SERVICE BULLETIN QUA/03/001

(QUASAR AMUSEMENT RIDE)

SEPTEMBER 1988

SERVICE BULLETIN QUA/03/002

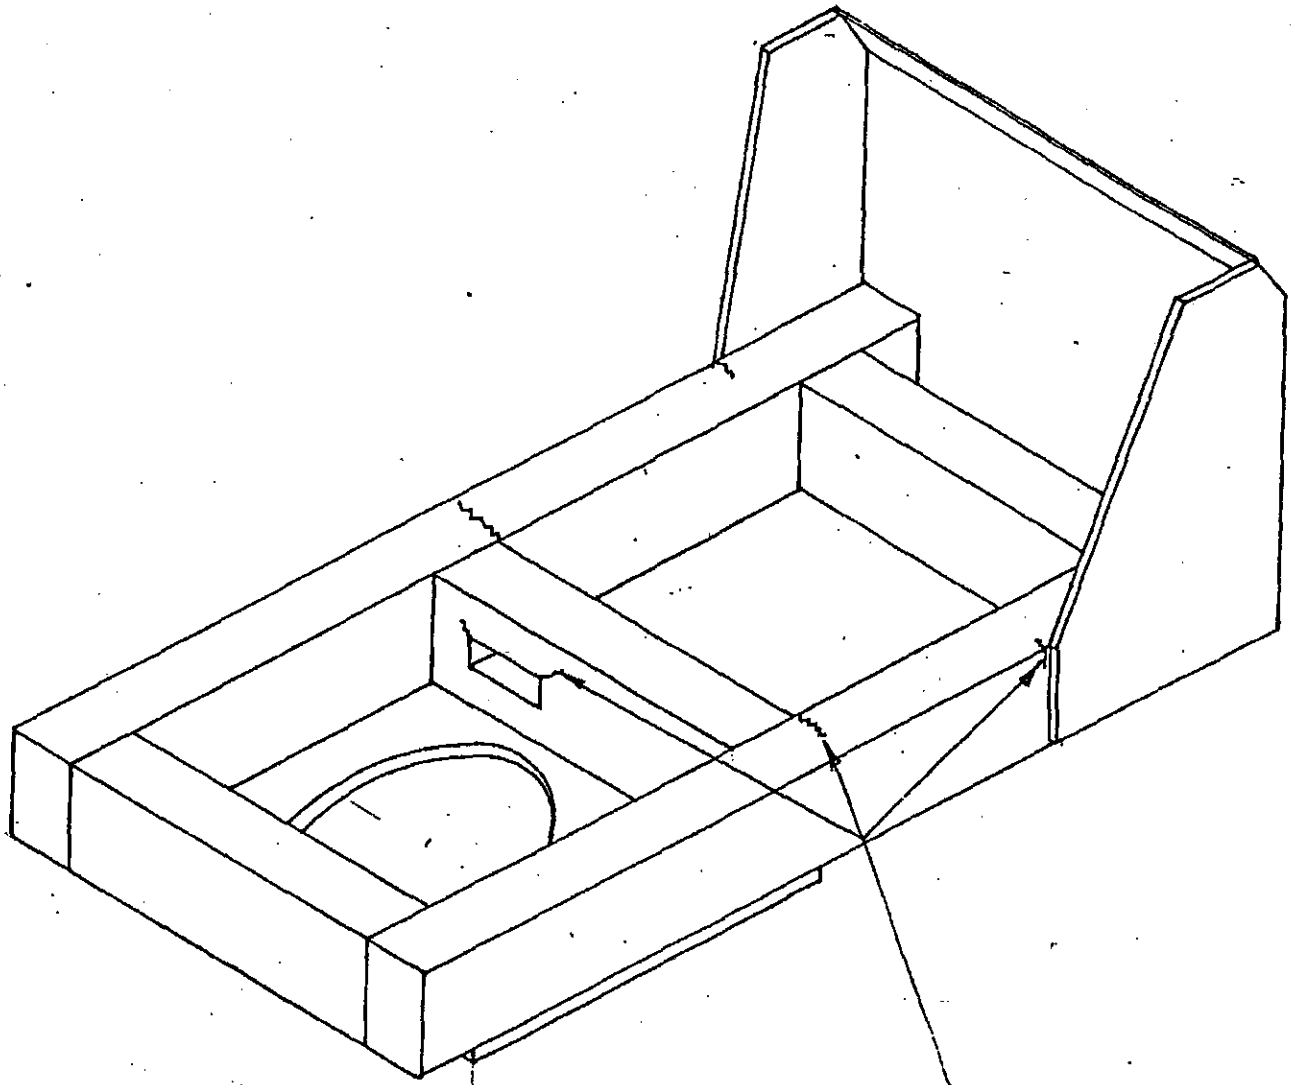
1. Repair any existing cracks in the top of sidemembers by grinding out to full depth and butt welding with a full penetration single 'V' butt weld.

These welds to have a root run by manual metal arc using a 5mm low hydrogen electrode. Remainder of weld may be by manual metal arc or M.I.G.

After completion of weld, grind down flush with surface of member giving a smooth crack free surface.

ORIGINAL CONSTRUCTION

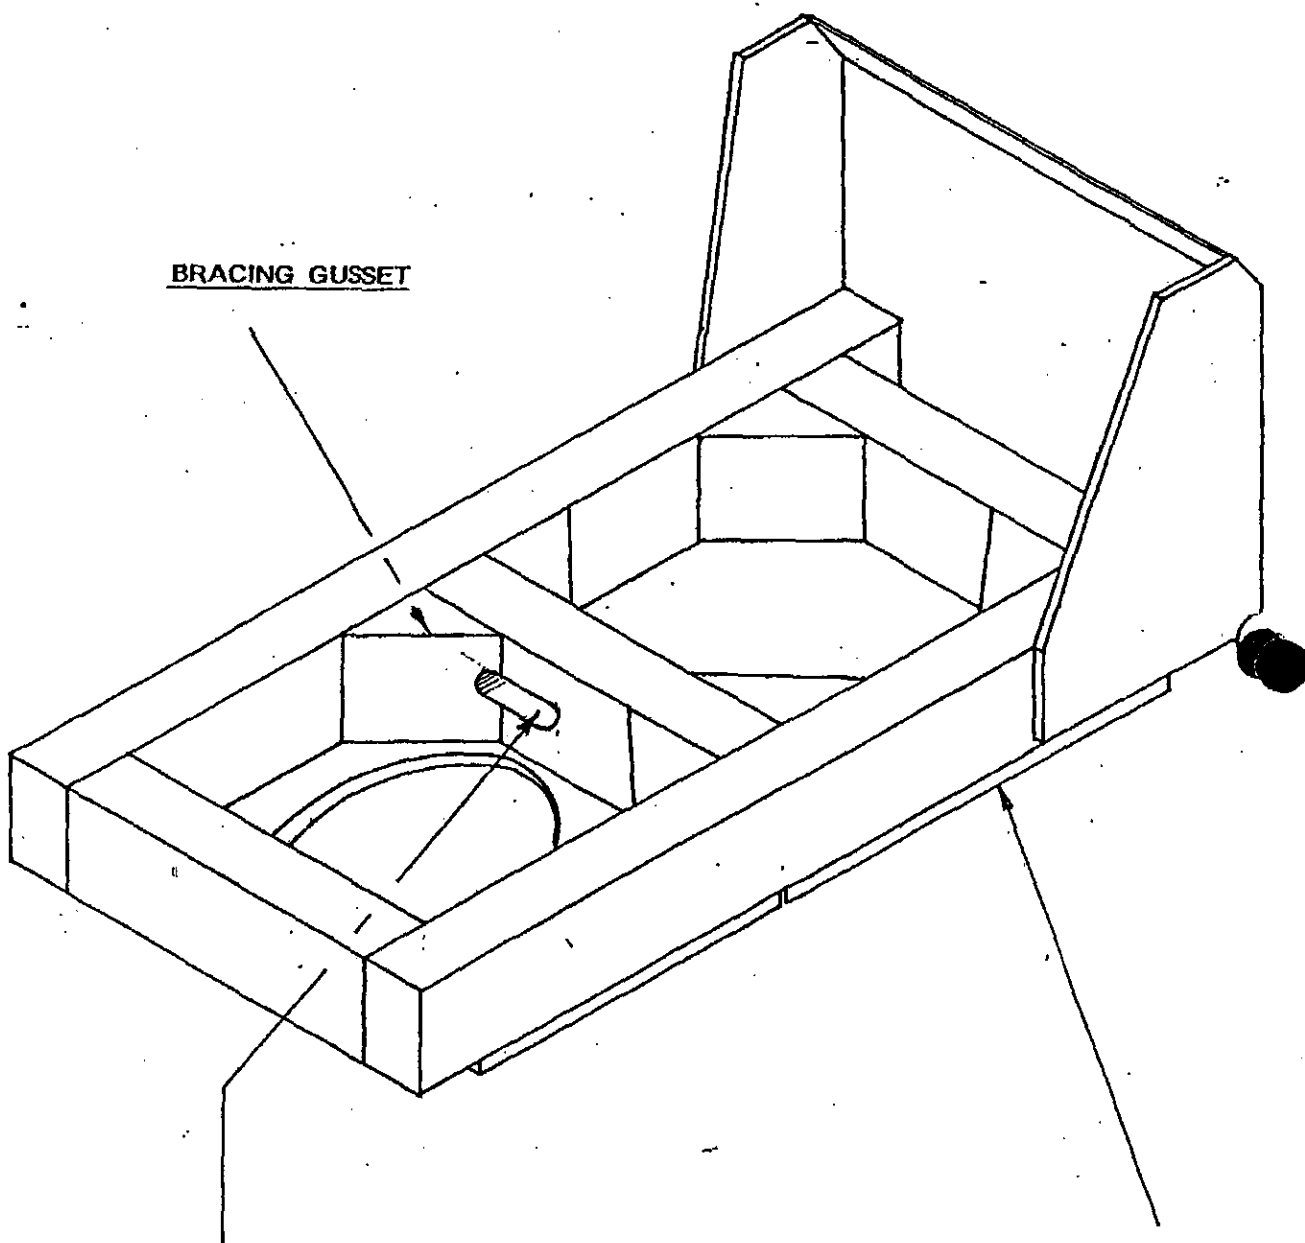
After examination and assessment it has been concluded that the cracking is fatigue initiated due to the presence of geometrical discontinuities in the vicinity of the tensile fibres of the main side members and forward crossmember.

These discontinuities in the form of weldments and square profiled pipe slot produce local stress concentrations and initiate cracks in the tensile fibres.

1. Bracing gussets to connect side members, crossmembers and lower plate. This will reduce moment arm on sidemembers and increase torsional stiffness, thus reducing stress levels and stress range in this vicinity.
2. Stiffening plate on underside to lower neutral axis and increase section modulus on tensile flange of sidemembers in the XX plane. This will also increase torsional stiffness and bending stiffness in the YY plane.
3. Modification to the profile of pipe slot in forward crossmember by radiusing the ends of slot, thus removing the local stress concentration present at the upper square corners of the original slot.

PIPE SLOT DETAIL

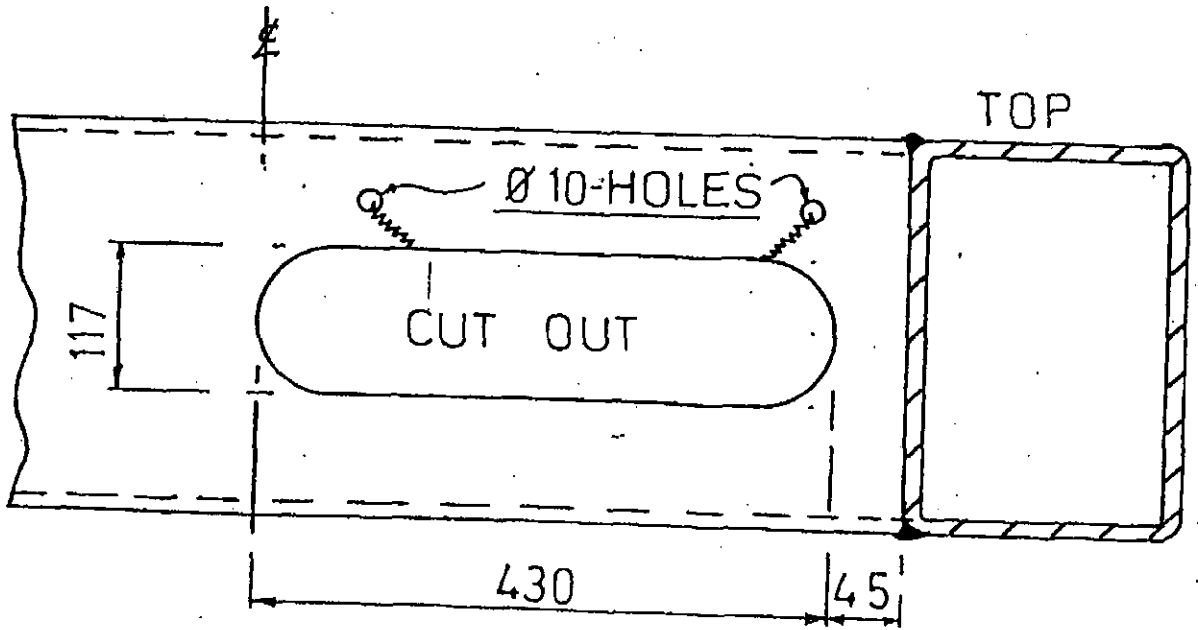
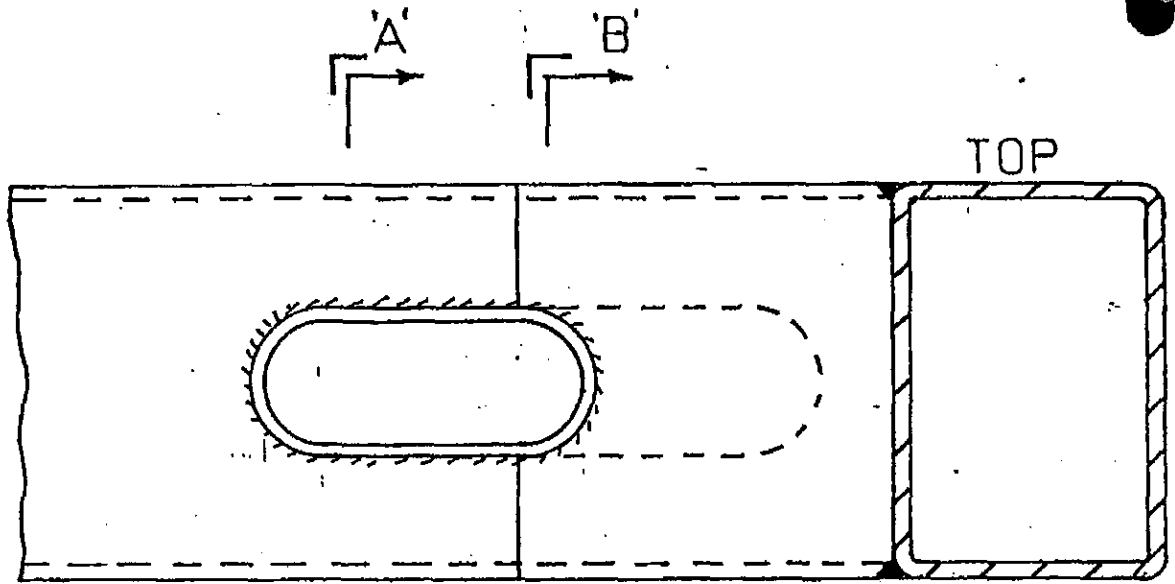
2. Repair any existing cracks in crossmember located at the top corners of pipe slot by drilling a 10mm diameter hole at the upper end of cracks as depicted on page 6. No further action is required.
3. Modify shape of pipe slot as depicted on page 6. Remove any drag lines from flame cutting and grind smooth.
Weld pipe slot flange part no. QUA/01/4 into position as depicted on pages 7 and 8.
4. Weld lower stiffening plate into position. Weld type as depicted on pages 11 and 12.
5. Weld gussets in the vicinity of pipe slot into position, part no. QUA/01/2 and QUA/01/3. Weld joint type and corner detail as depicted on pages 5 and 12. Weld remainder of gussets in position. Part No. QUA/01/1.
6. The weld connecting the sideplates to the top of sidemembers is to be ground flush with top surface of sidemembers for the last 150mm of its length. See pages 10 and 12.

ORIGINAL CONSTRUCTION (STRAIGHT TYPE)

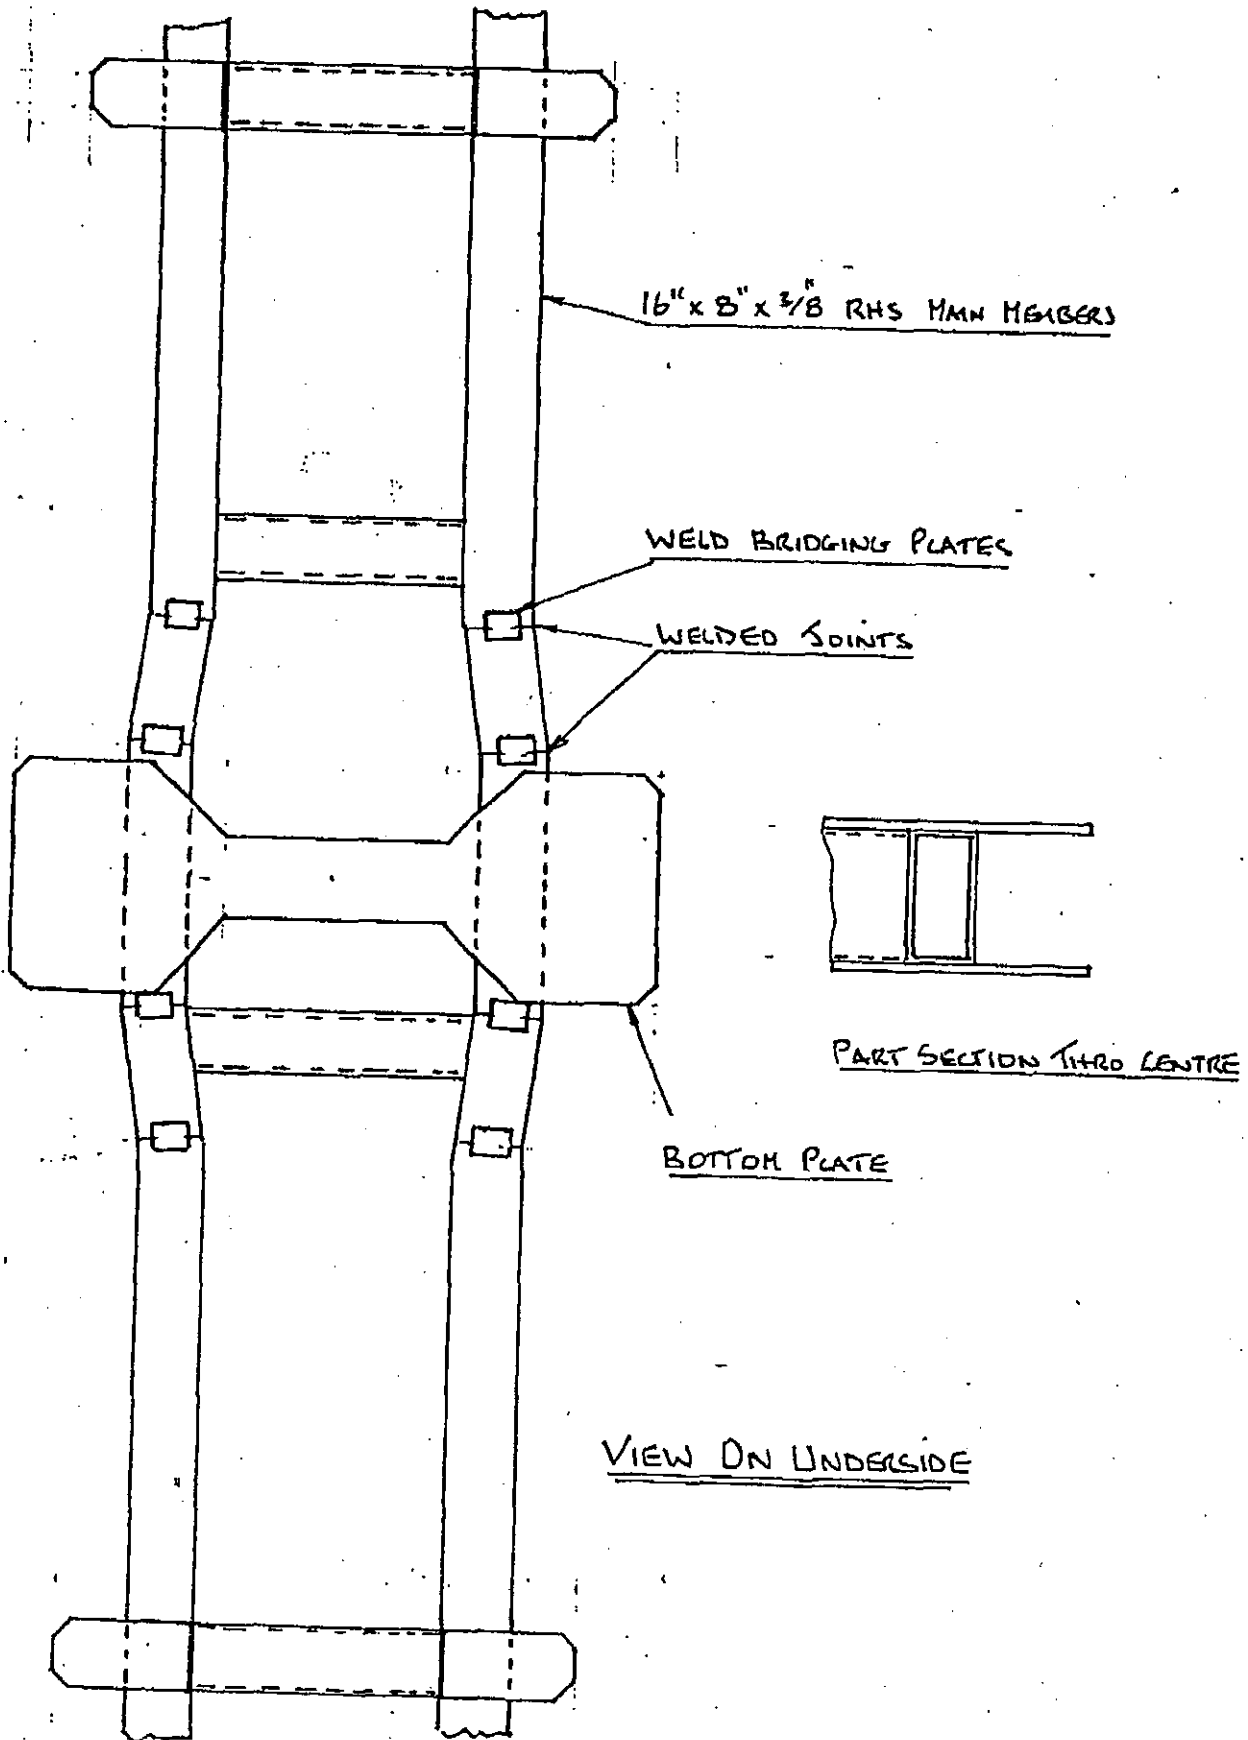
The picture is further complicated by their being two types of trailer construction, viz Type 1 with cranked main longitudinal members and Type 2, with straight members. The cranked version gives most cause for concern because the members are cut, bent and then welded which places a weldment at right angles to the stress lines in the tensile zone. This weldment then initiates cracks on the underside of the main members which propagate outwards and upwards.

MODIFIED CONSTRUCTION (STRAIGHT TYPE)

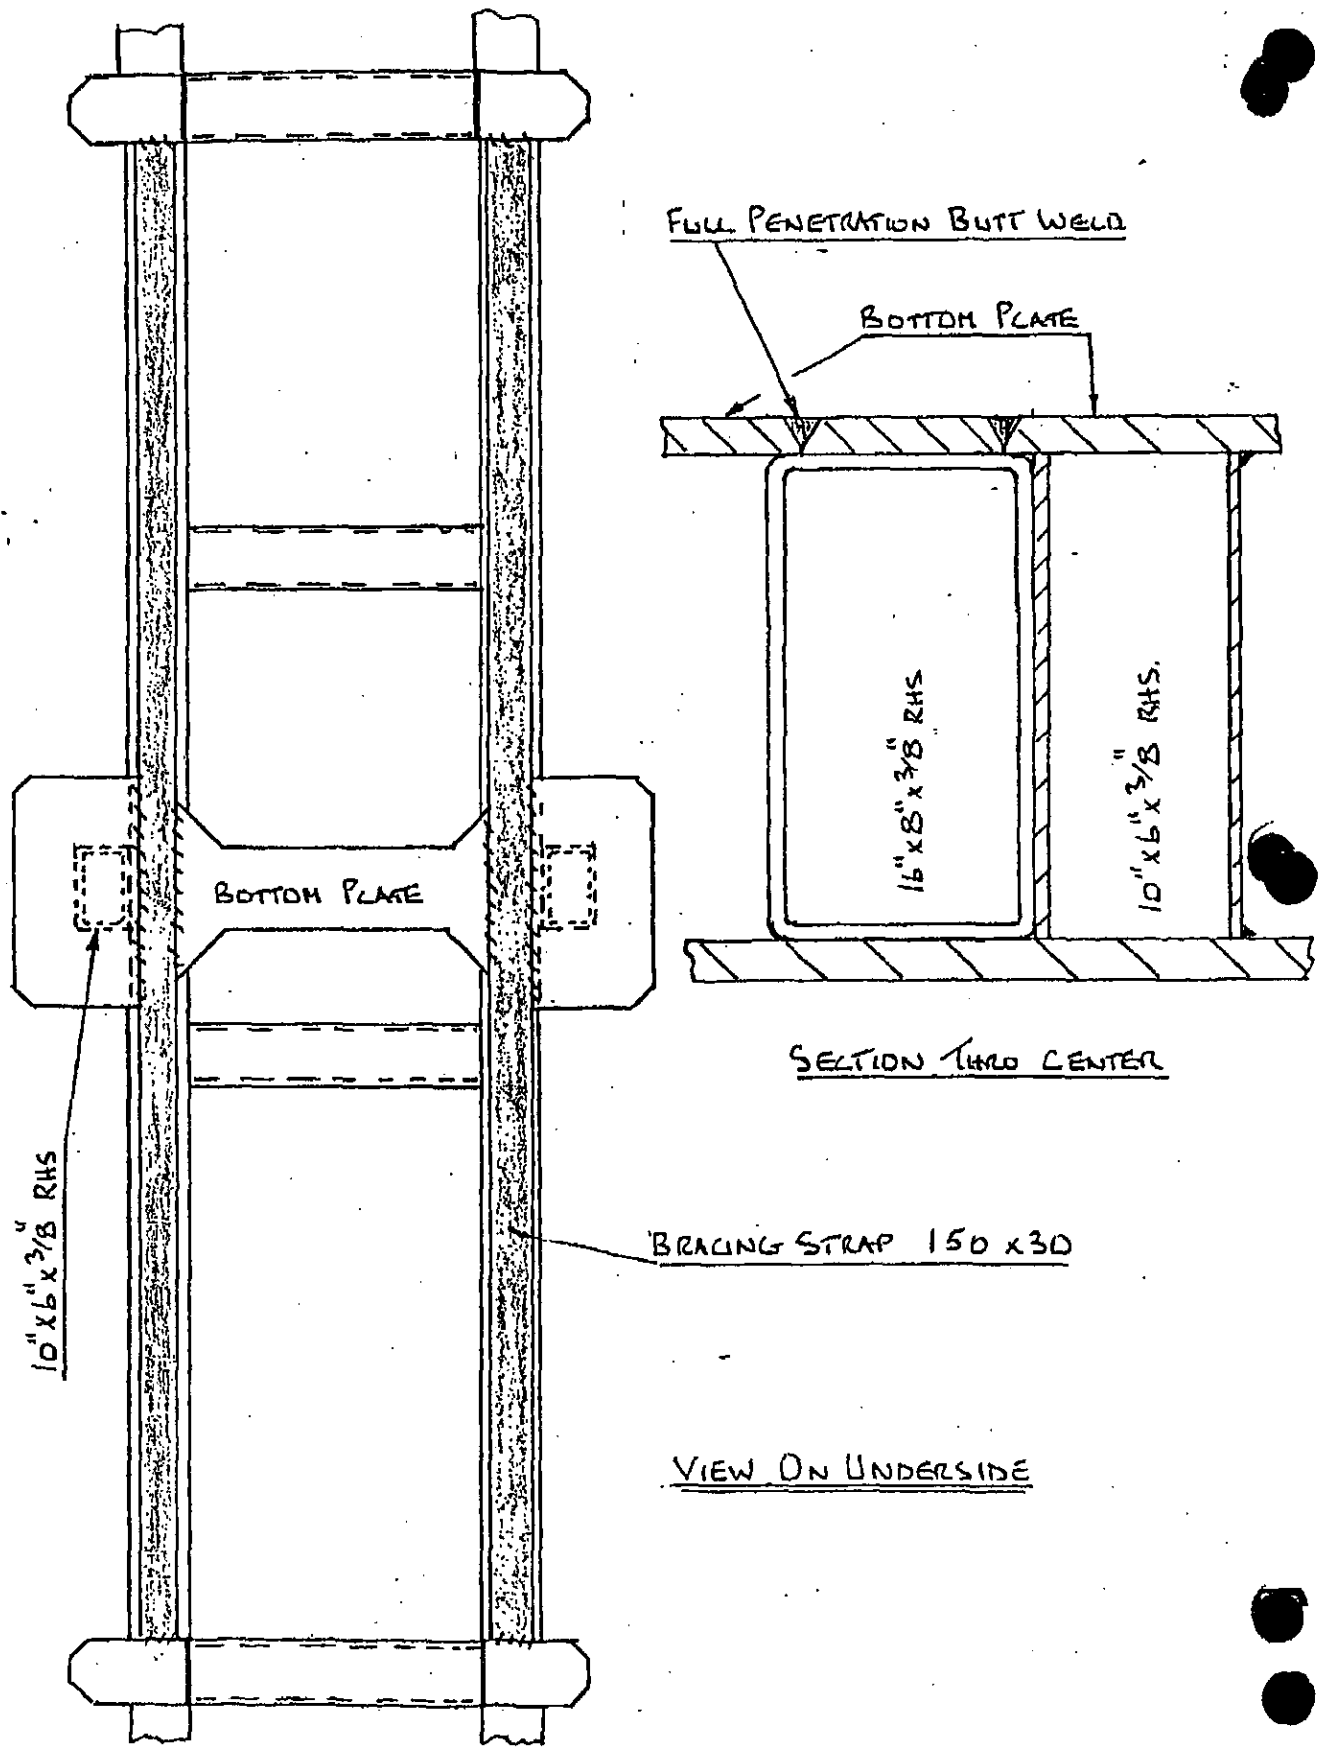
1. Bracing strap to be fitted on underside of main members.
2. Bracing member fitted vertically between top and bottom plate and connected to side of main members.

2. Cut out a 160mm wide section of bottom plate above both main members to allow bracing strap to pass along surface of main members - see Page 6

Weld prep edges of bottom plate and bracing strap as depicted on Page 6. Weld bracing strap to underside of main members then weld bottom plate to bracing strap as depicted on Page 6.

3. Weld bracing member between top and bottom plates and side of main members as depicted on Page 6
